**WHITLEY COUNTY ADVISORY PLAN COMMISSION
STAFF REPORT**

24-W-SUBD-6 PRIMARY REPLAT APPROVAL

**MARCH 20, 2024
AGENDA ITEM: 3**

“Green and Tran Addition”, northeast corner Fish Hatchery/Colony Ave.

GREEN & TRAN ADDITION (PRELIMINARY)

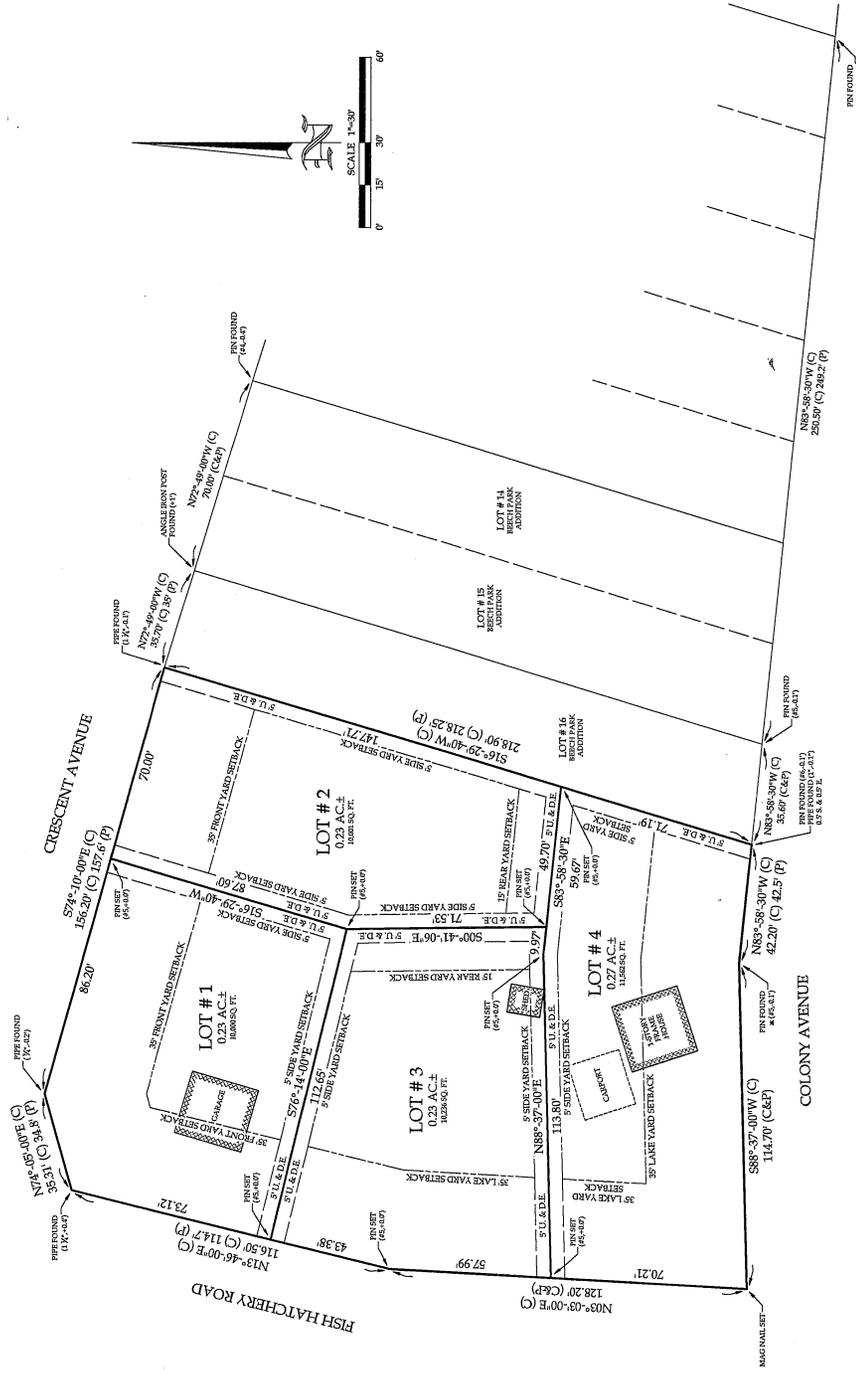
Note that the petitioner could reestablish the existing platted lots without the need for replatting or conformance with current zoning standards. However, the desired reconfiguration of the lots triggers the need for this replatting; it also creates lots in compliance with current zoning standards (per previous precedent, replats of LR-zoned lots retain 5' side yards). The legal nonconforming status of the existing improvements will not change, with the exception of a small shed that would be within a proposed setback on Lot 3.

5' drainage and utility easements are shown on the perimeters of the lots.

Being a replat of a subdivision that previously dedicated right-of-way, it is policy not to require additional right-of-way for the perimeter roads. If additional right-of-way were to be required to meet the minimum 50' width for subdivision roads, roughly 10' would need to be dedicated along Crescent and Fish Hatchery, and a varying amount up to 10' along Colony.

1. Move the shed currently located on proposed Lot 3 to conform to the minimum setback prior to sale of the lot.
2. The Health Department should be consulted to affirm that the location of any existing wells meets their requirements.
3. Secondary plat approval delegated to the Plan Commission staff.
